# ABTR STORAGE SITE DEVELOPMENT PLAN **COVER SHEET** APRIL 2023

Include PCD File No. PPR2319

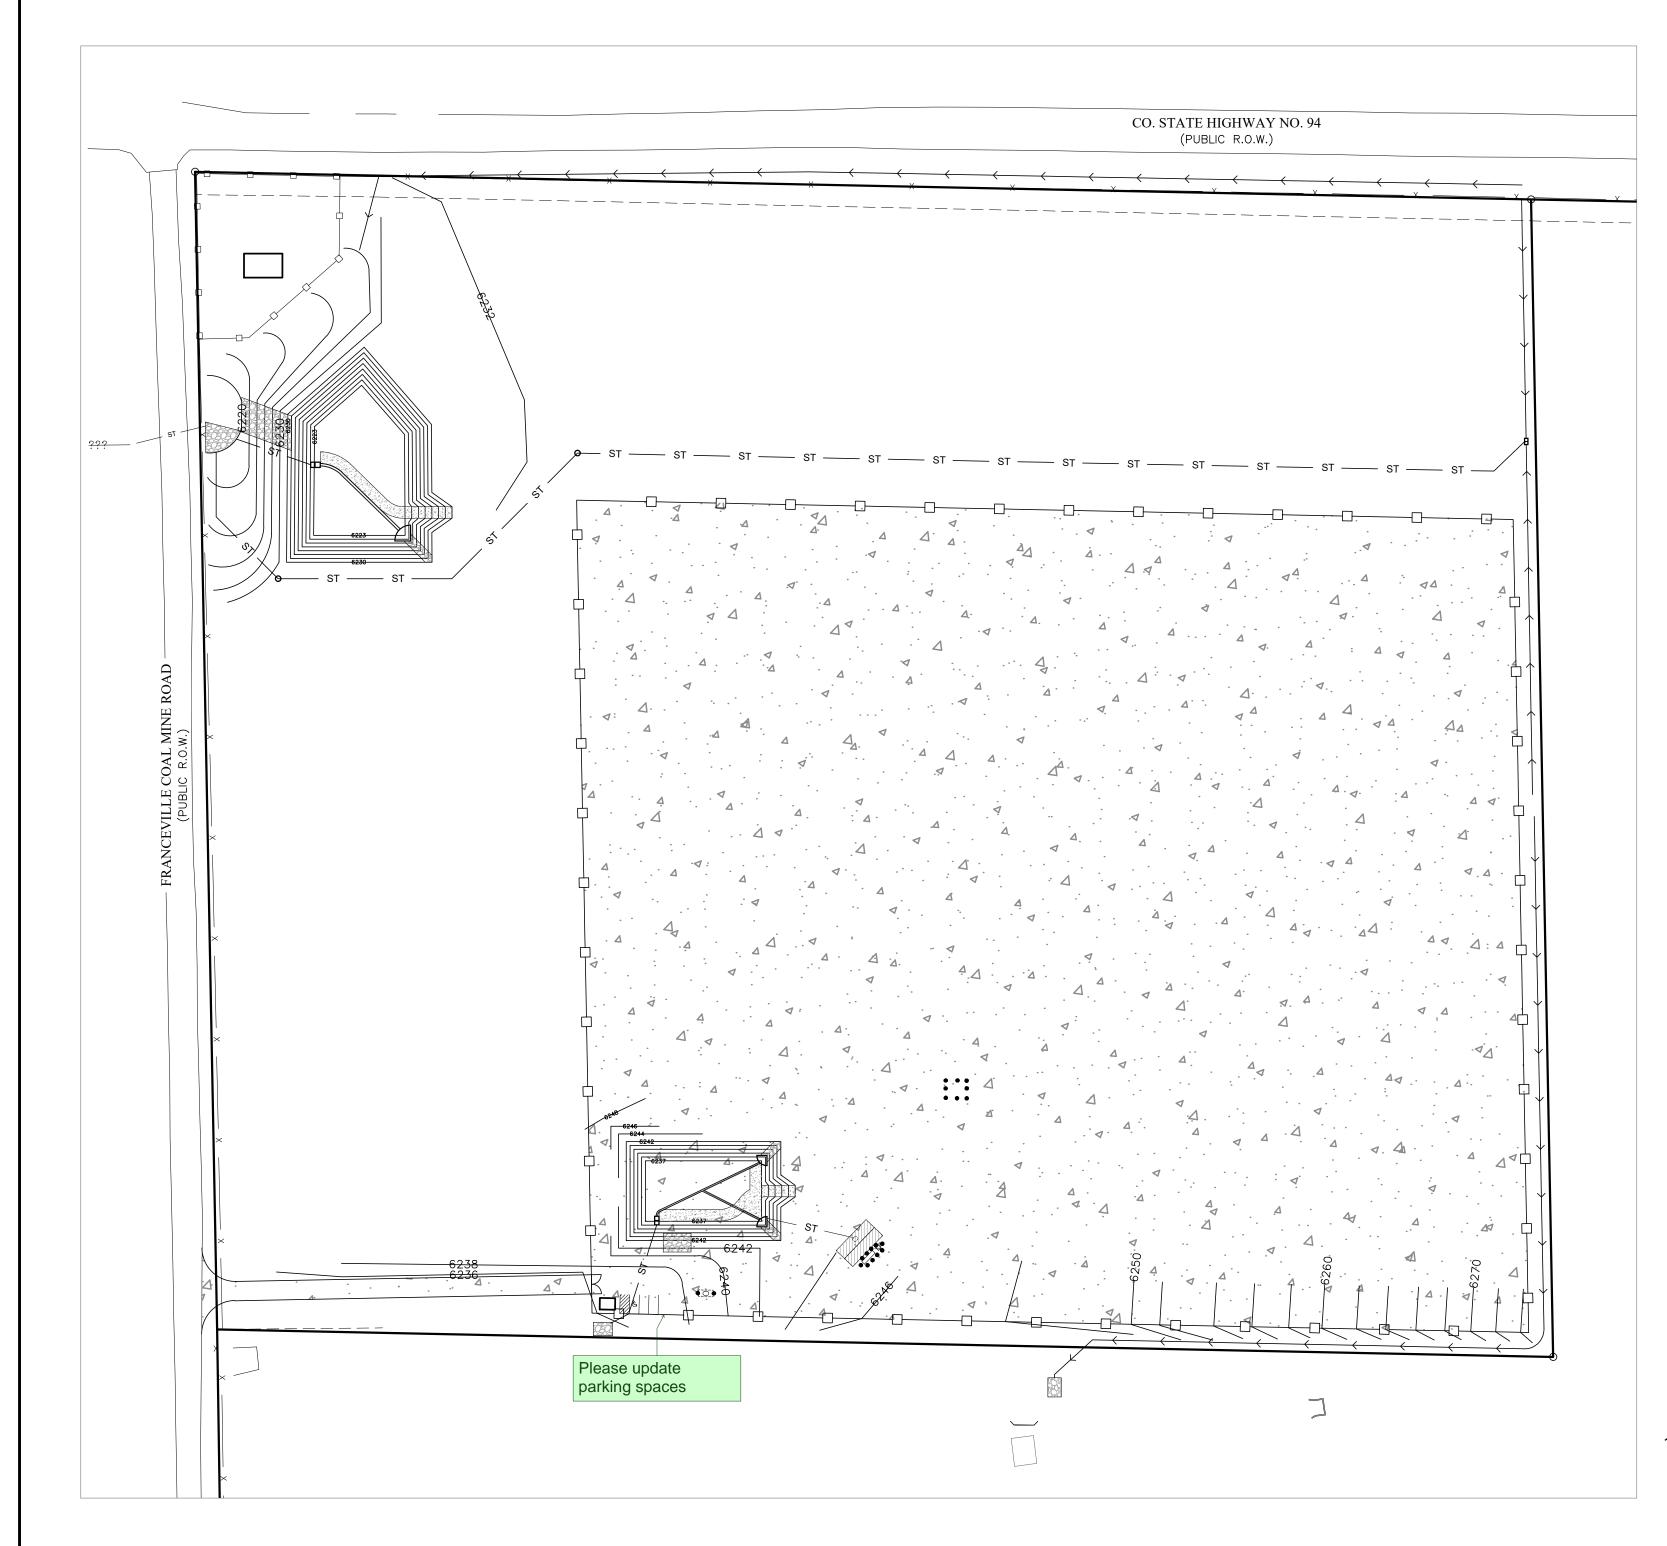
Is this for the existing shed? This aligns with the size of the building provided in the elevations but it is not clear. I would recommend separating out existing buildings and proposed buildings. Confirm whether there are any proposed

How many spaces? Other

Land Development Code.

documentation refer to the proposed

use as "automobile and boat storage yard" which falls under the use

classification of "outside storage" in the

The disabled space is

in addition to the 3 required spaces. There should be 3

standard parking

disabled parking

space, for 4 total

spaces and 1
